| | | | | | | |
|---|--|---|--------|--|-------------|----------|
| TYPE NO FB 55 | TYPE Coffe Vending Machines | T.I. NO 01 - 2015 | | | | |
| SERIAL NUMBERS AFFECTED From and including S/N 42611082 | ISSUED BY Documentation/N&W Valbrembo | | | | | |
| SUBJECT KIT FOR NEW WATER INLET | | ISSUED FOR (X): <table border="1"> <tr> <td>Action</td> <td></td> </tr> <tr> <td>Information</td> <td>X</td> </tr> </table> | Action | | Information | X |
| Action | | | | | | |
| Information | X | | | | | |

Due to the expired food approval for the EPDM material (it is in general no longer allowed in food applications) it has introduced the new material called Soft Pex and a new water inlet hose is needed: a specific "KIT for new water inlet" has been created.

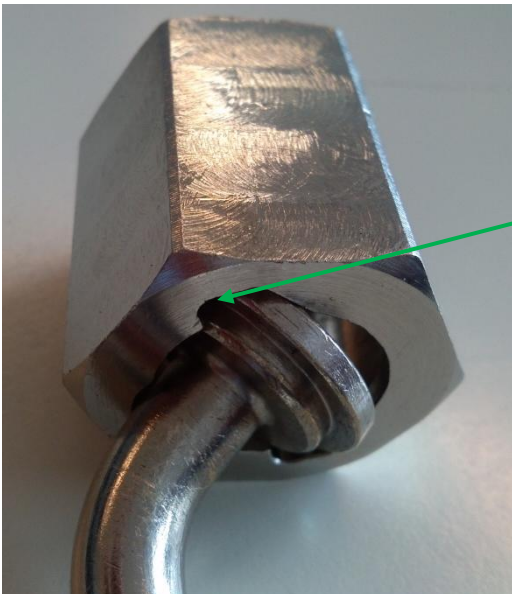
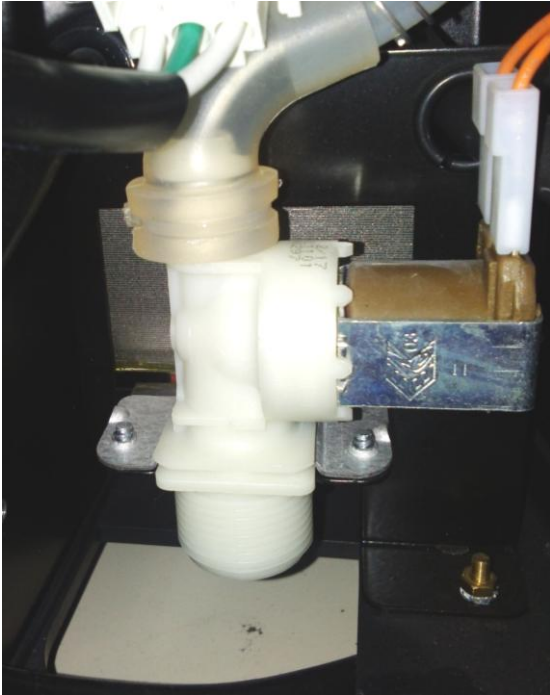
New water inlet HOSE:
 detail of the connection (90° not flexible metal hose) to water inlet valve +
 NUT 3/4 GAS **normal**

The "NUT 3/4 GAS long" allows to connect the metal hose to the inlet valve.
 The specific NUT design allows to assembly the nut and the metal hose
